AGENDA
City of Gig Harbor Design Review Board
Virtual Meeting of February 25, 2021 at 5:00 pm

**COMMUNITY DEVELOPMENT DEPARTMENT
PLANNING DIVISION
STAFF REPORT**

RE: PL-DR-20-0071 – Gig Harbor Peninsula FISH Food Bank
Public Meeting Date: February 25, 2021

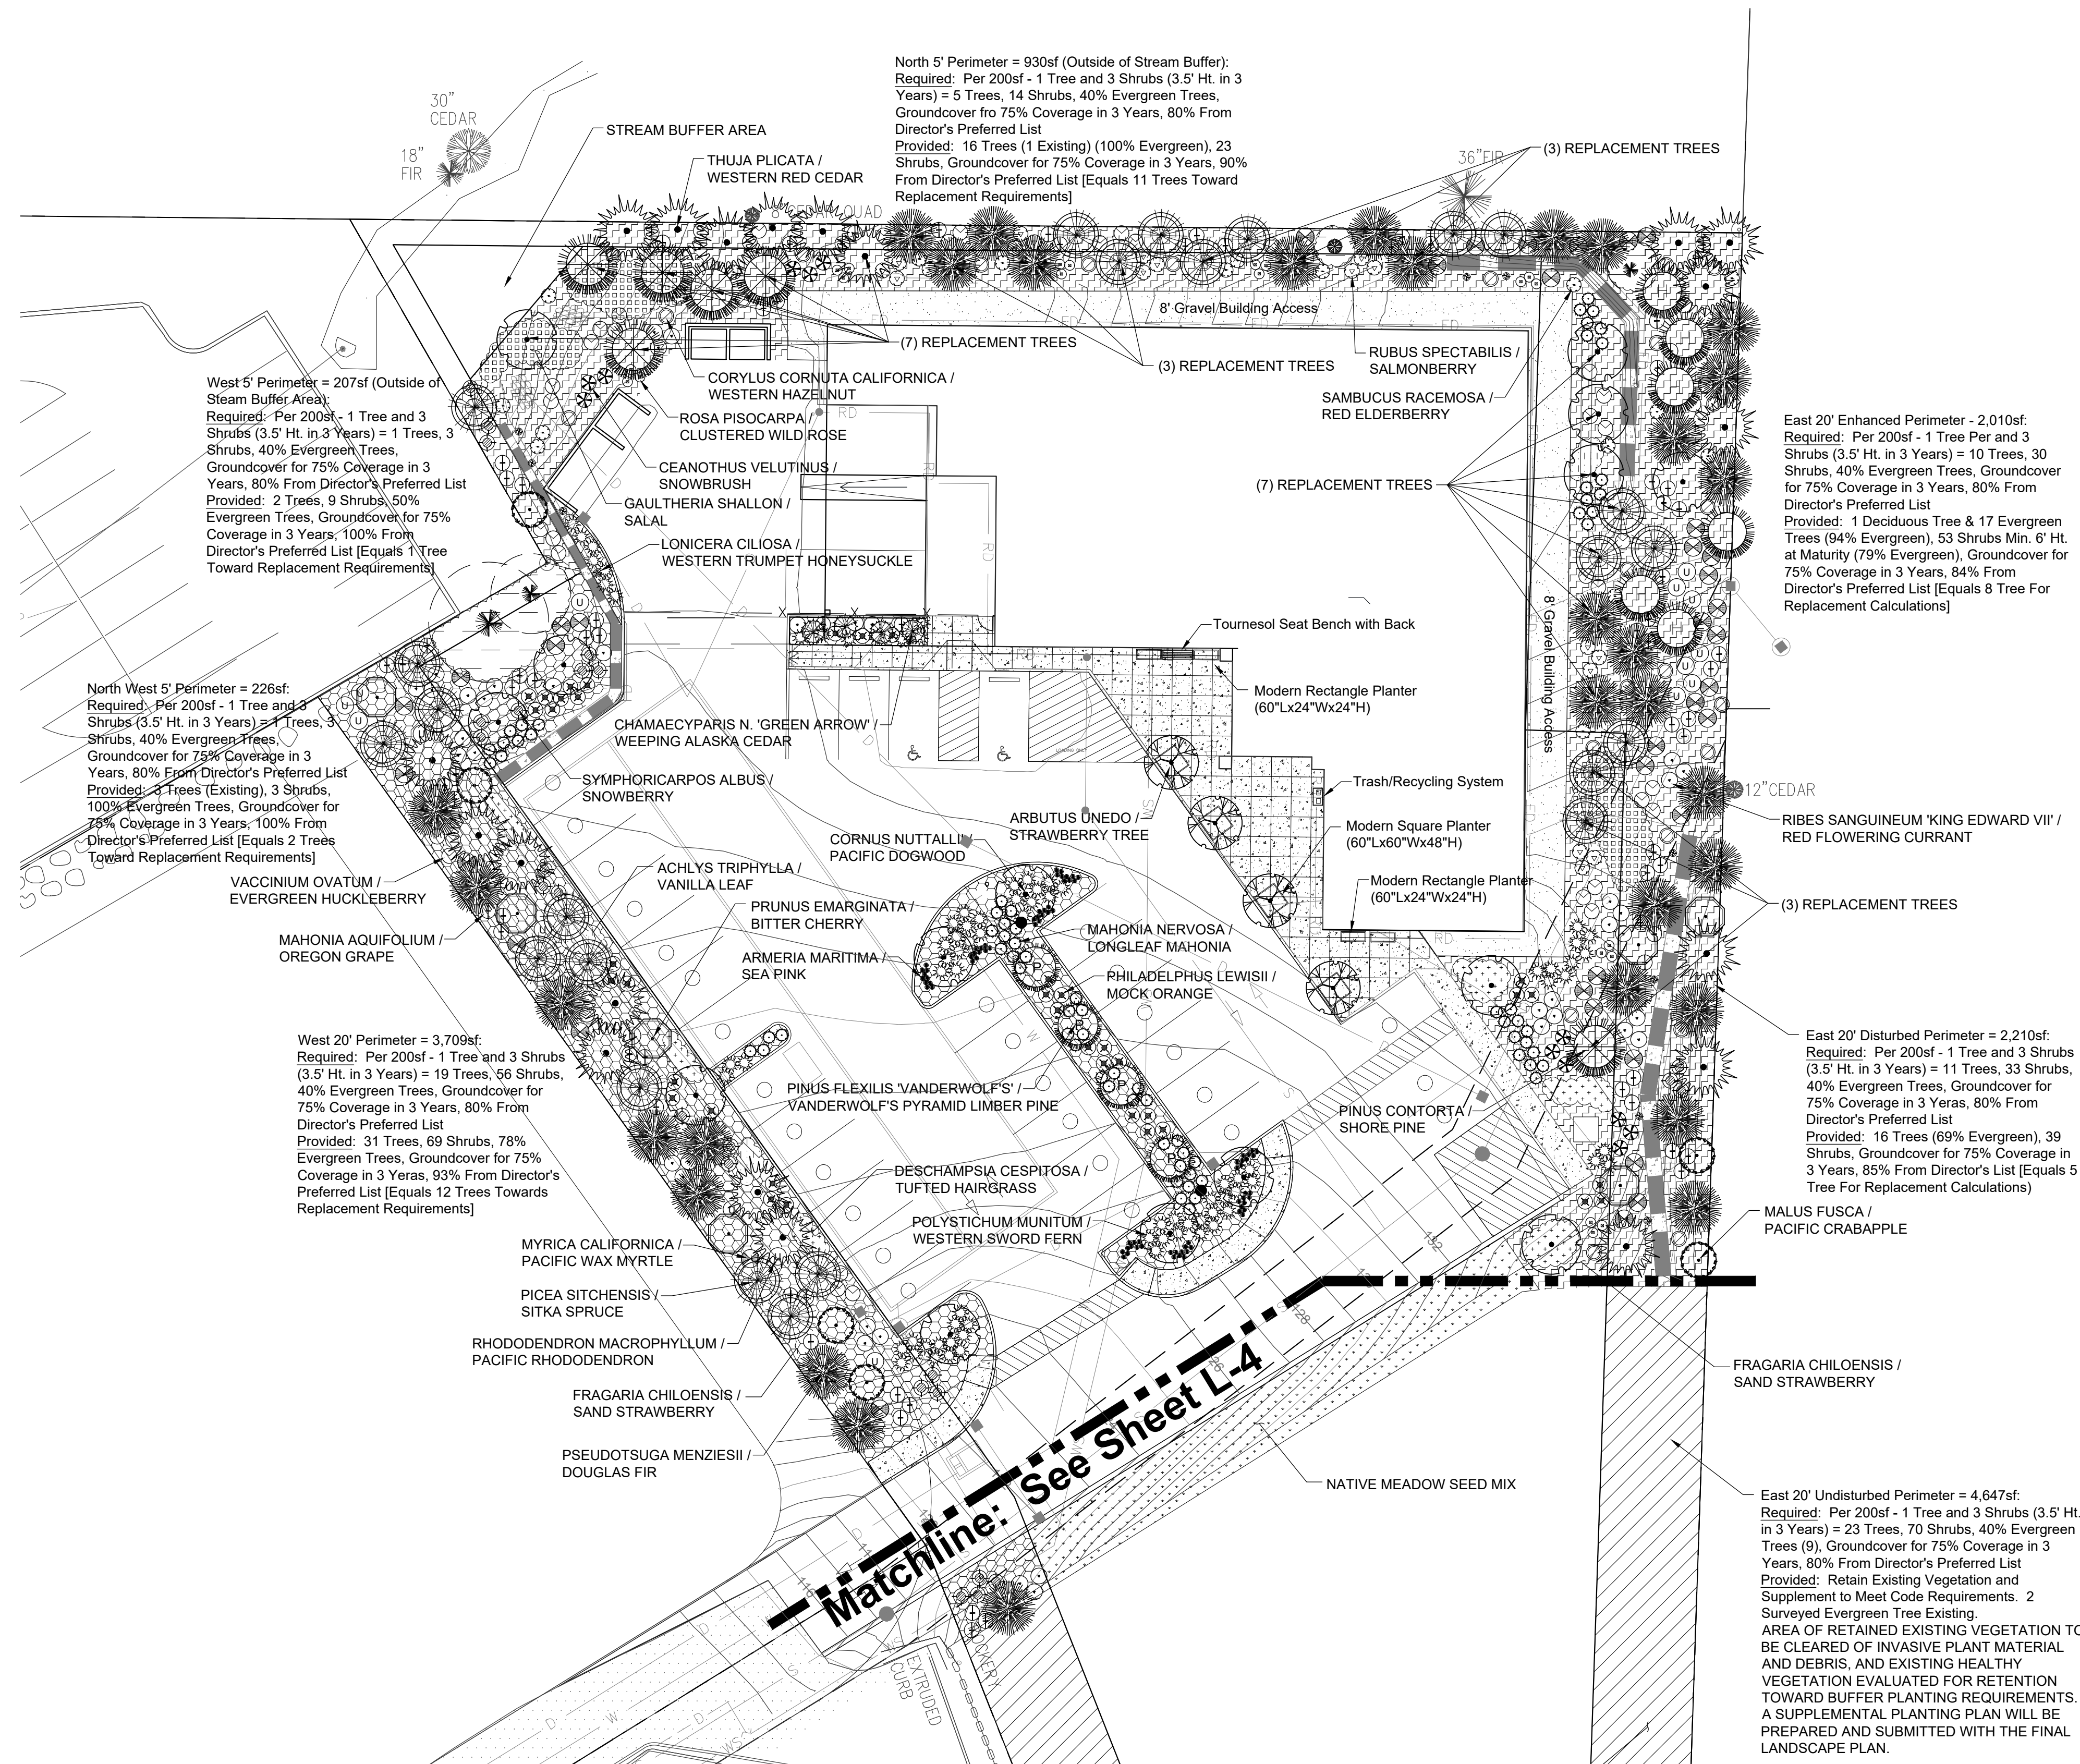
1. **Applicant's Request:** The applicant is requesting the DRB review and recommend approval of its alternative design proposal to the site's primary walkway requirement to provide a five-foot wide landscaping strip to the building's entrance. See Sheet L-3 and pages 2-3 of Exhibit

The applicant notes that, considering the above, the proposed alternative landscaping of four (4) 5' x 5' raised planters with *Arbutus unedo* (strawberry tree) planted in each, and two (2) additional landscaped planters along the southern façade of the proposed structure, introduces an equivalent or superior design solution which is consistent with the intent of GHMC 17.99.260(D).

The proposed Alternative Landscape Plan, Sheet L-3, shows (4) 5' x 5' raised, moveable planters with trees, attractively arranged around the entry, plus (2) additional planters against the south end of the building, along the sides of the primary walkway where it widens and adjoins with the Common Area Plaza, which is a superior alternative solution for this common area entry plaza.

Overall Site

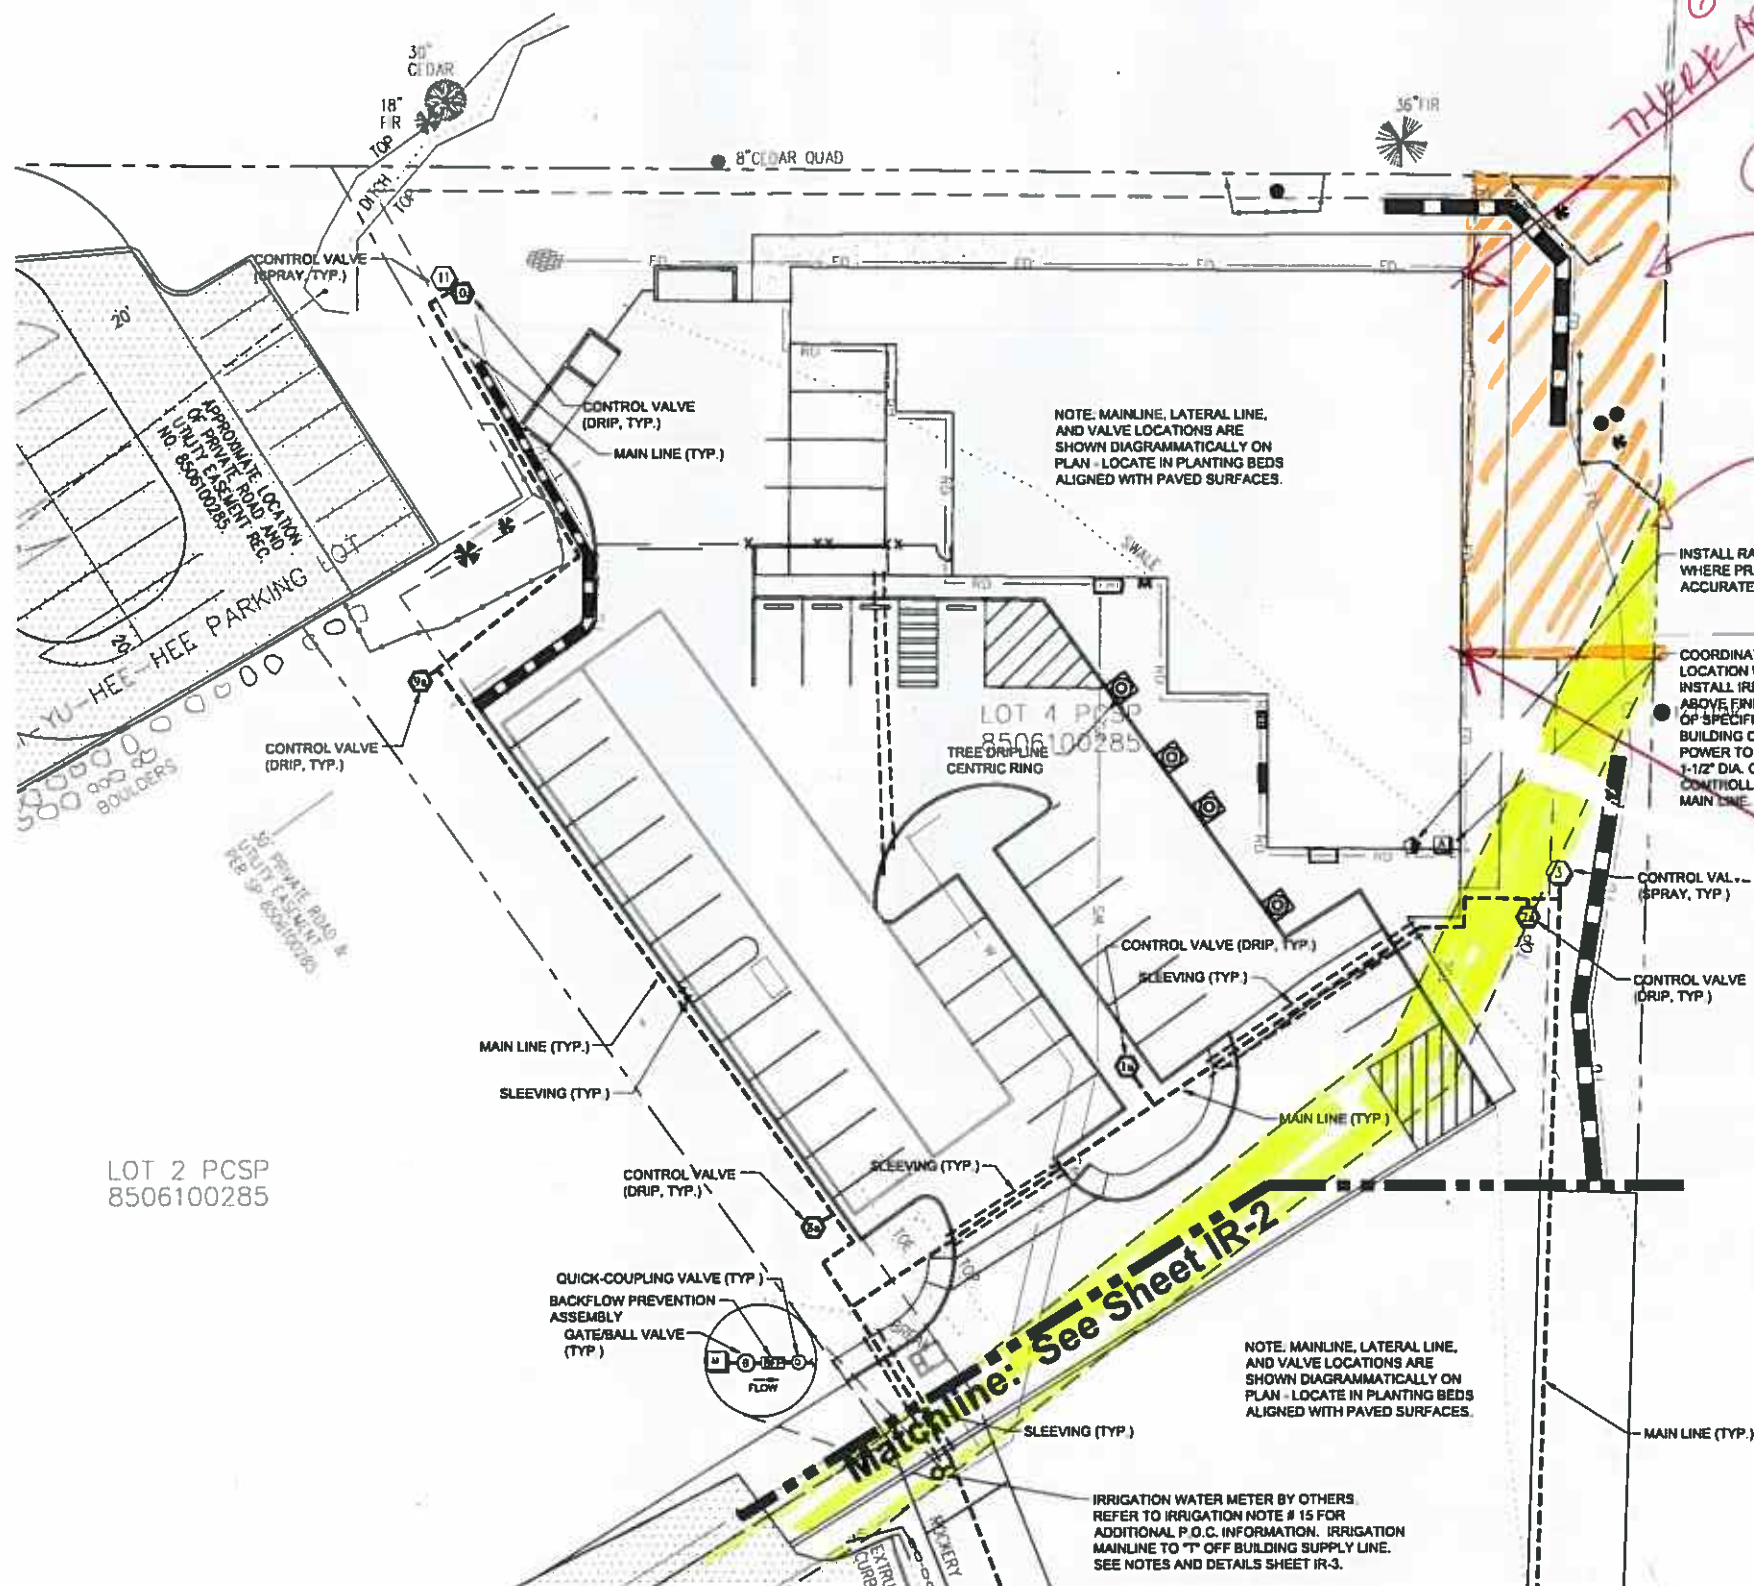
1. See attached IR-1, where sewer easement encroachment is shown in yellow.
2. According to the City's own Public Works standards 13.28.250 states it is unlawful to plant anything that would be likely to obstruct a sewer line.

DRAWING NO.
C1.1

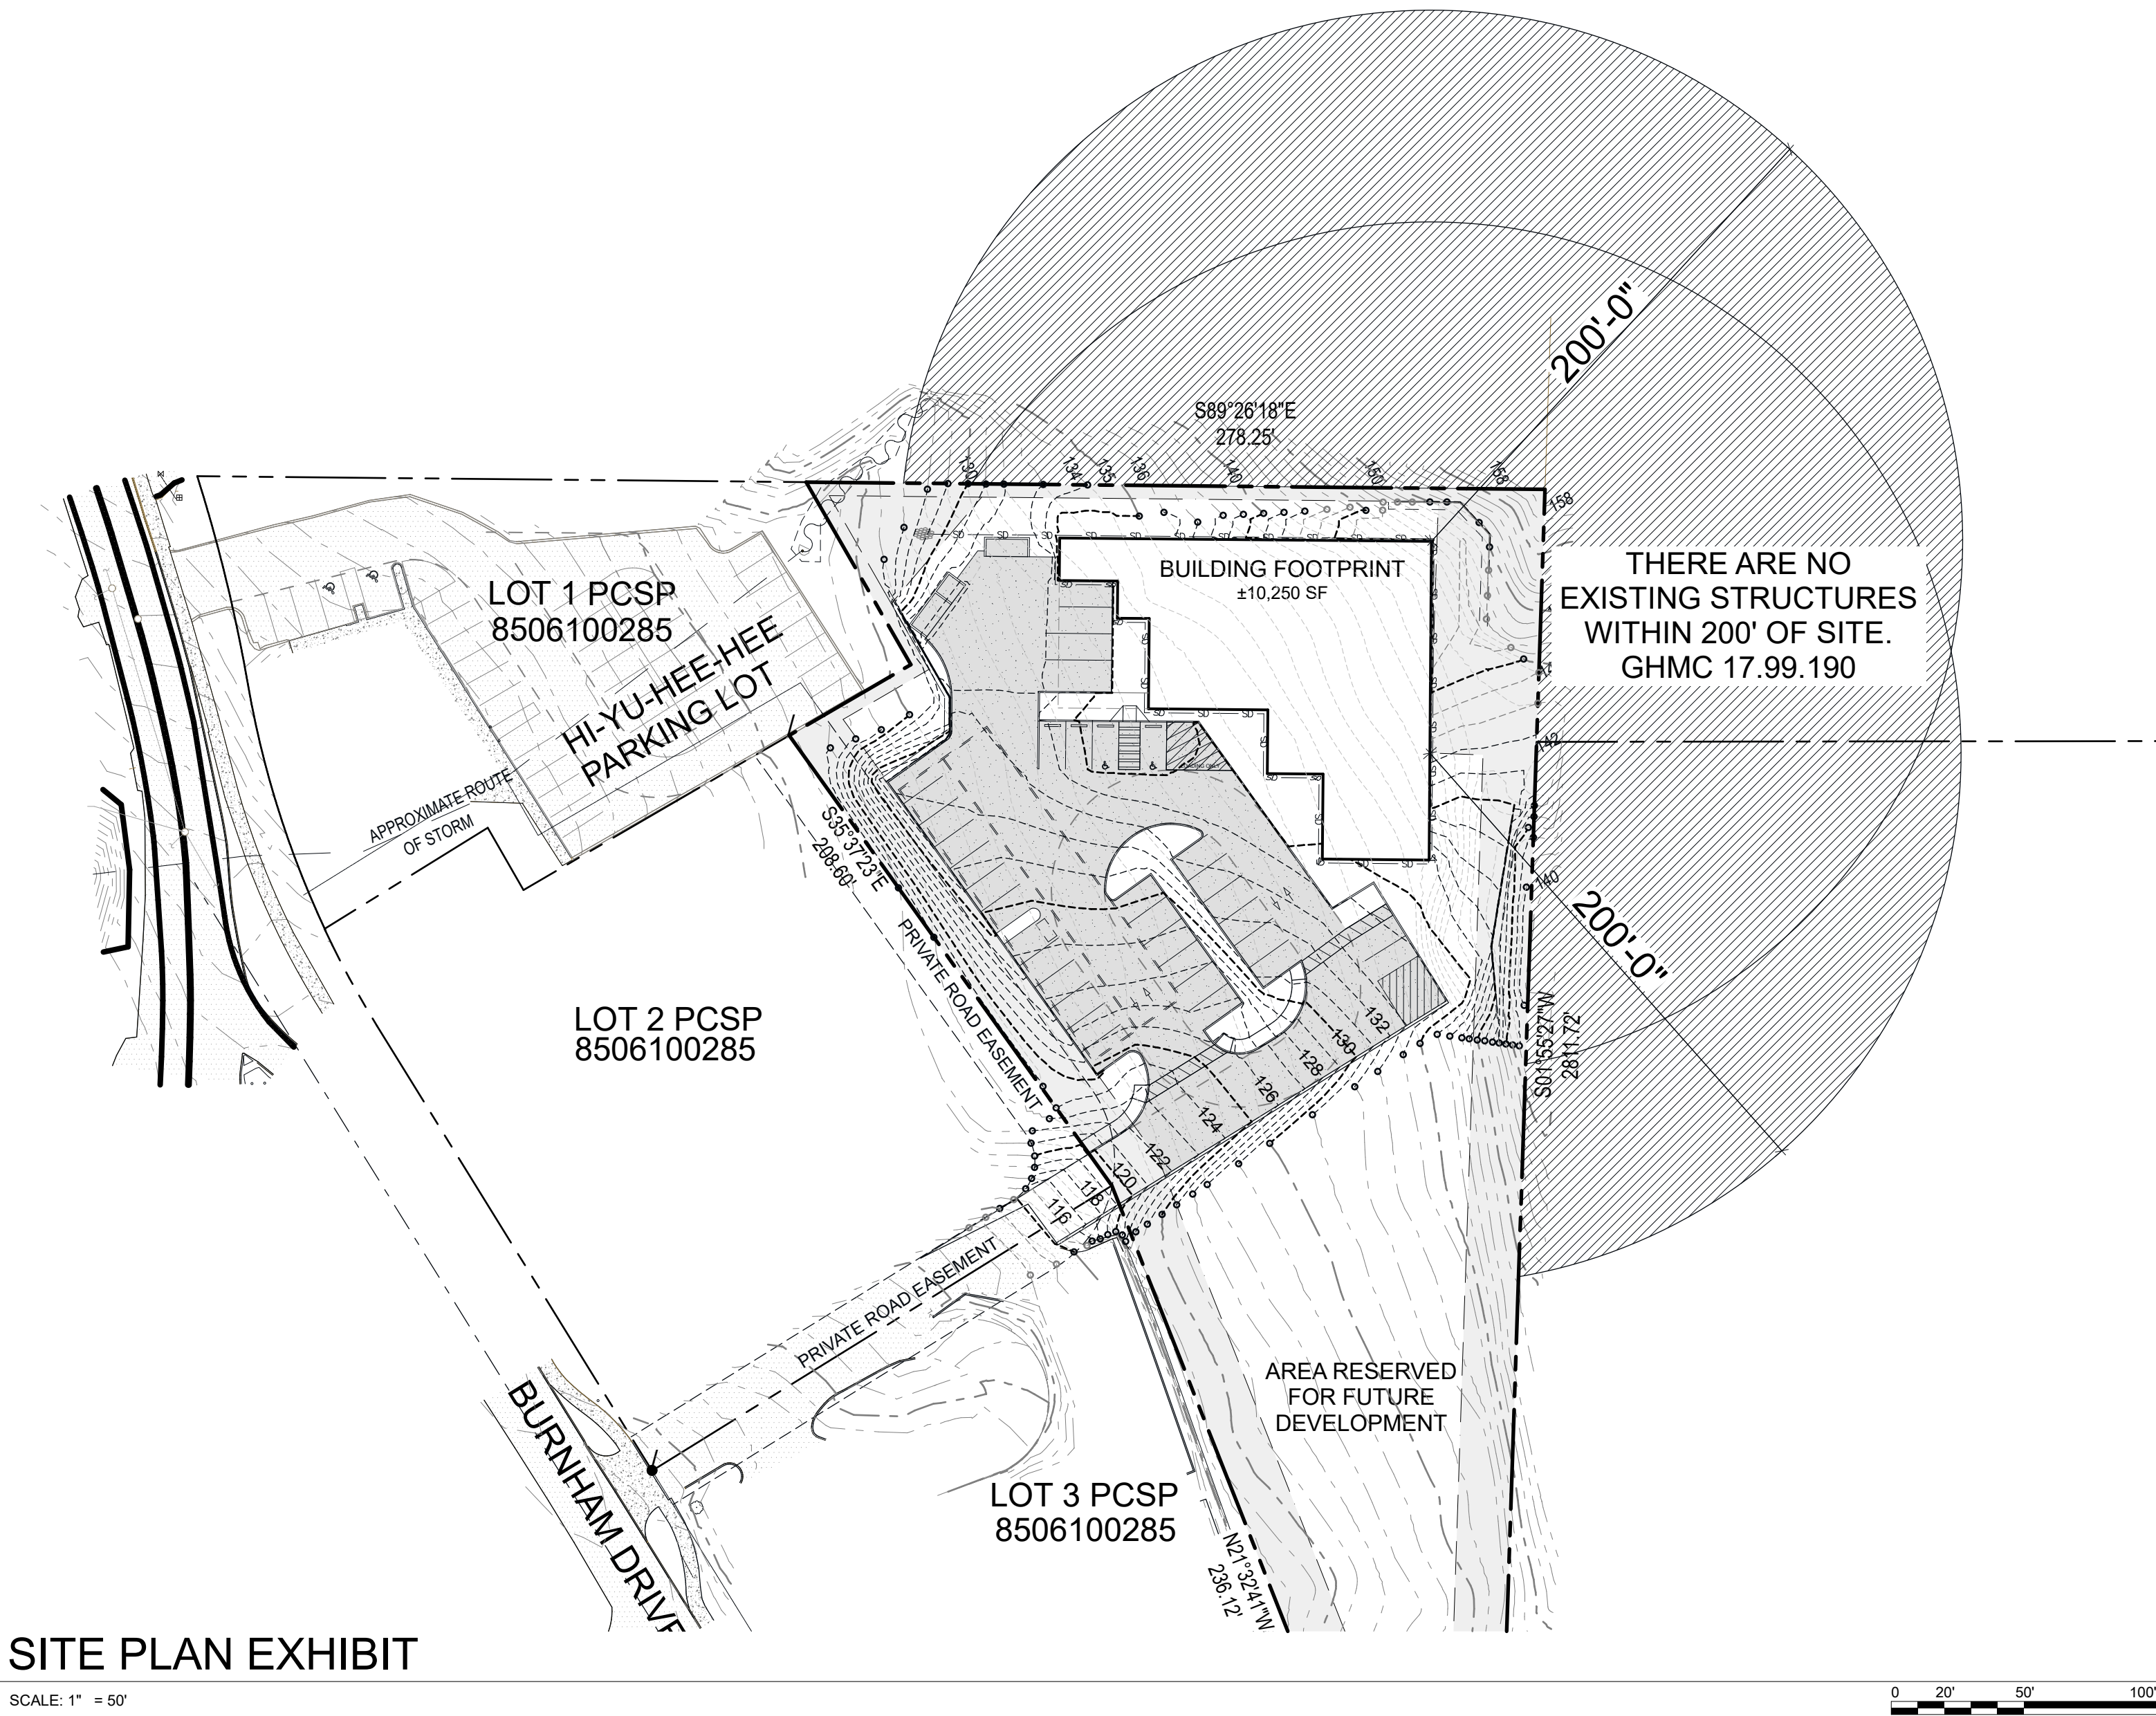
4. An LID riparian swale and/or pipe must be used to channel the flow which will prohibit the use of dense trees and shrubs at this location.
5. The uphill adjacent properties that have surface water to control are the R-1 Residential zone, and the Goodman Middle School Track areas. The proposed utility and storm lines are shown on Sheet C1.1.
